Record Plans
Contractor: PIKE INDUSTRIES, INC.
Resident Engineer: THOMAS A. CHASE
Construction Began: 07/12/2018
Construction Complete: 07/24/2019
Record Plans By: THOMAS A. CHASE

COMPOSITE
PROPOSED IMPROVEMENT
TOWNS OF CAVENDISH, READING, WEATHERSFIELD, WEST WINDSOR AND WINDSOR
COUNTY OF WINDSOR
VERMONT ROUTE 44, 44A & 106 (MAJOR COLLECTORS)

PROJECT NAME : READING-WINDSOR, WEATHERSFIELD-READING & WEATHERSFIELD-WINDSOR

PROJECT NUMBER : STP FPAV(11), STP FPAV(12) & STP FPAV(13)

BEGIN APPROACH COLD PLANE DETAIL

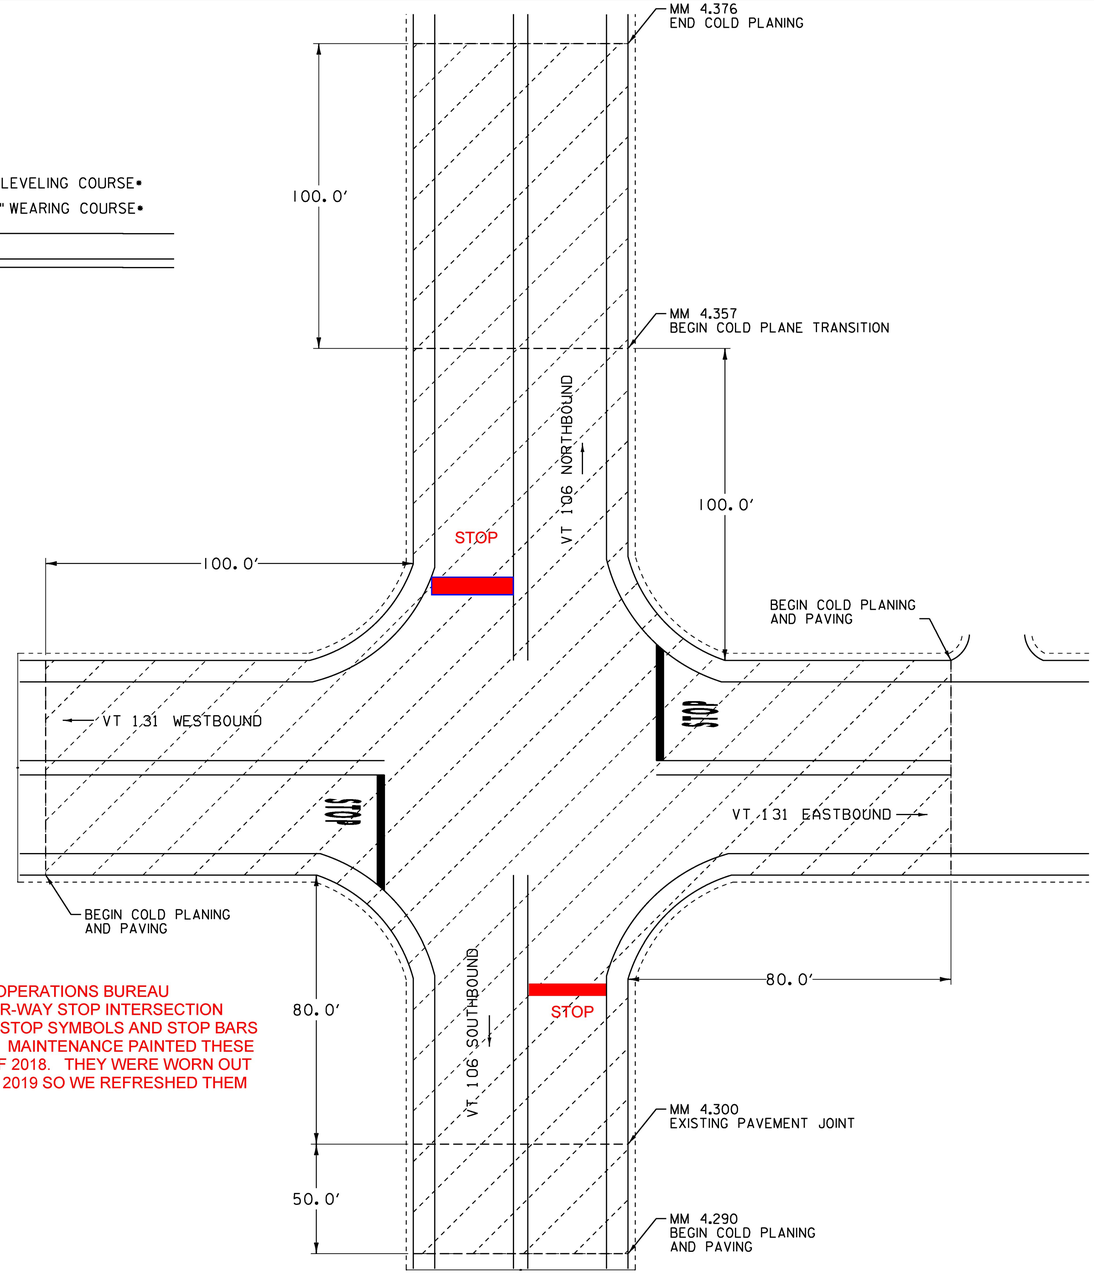
THE MAINTENANCE AND OPERATIONS BUREAU CHANGED THIS TO A FOUR-WAY STOP INTERSECTION DURING THIS PROJECT. STOP SYMBOLS AND STOP BARS WERE ADDED TO VT 106. MAINTENANCE PAINTED THESE SYMBOLS IN OCTOBER OF 2018. THEY WERE WORN OUT COMPLETELY BY SPRING 2019 SO WE REFRESHED THEM WITH EPOXY.
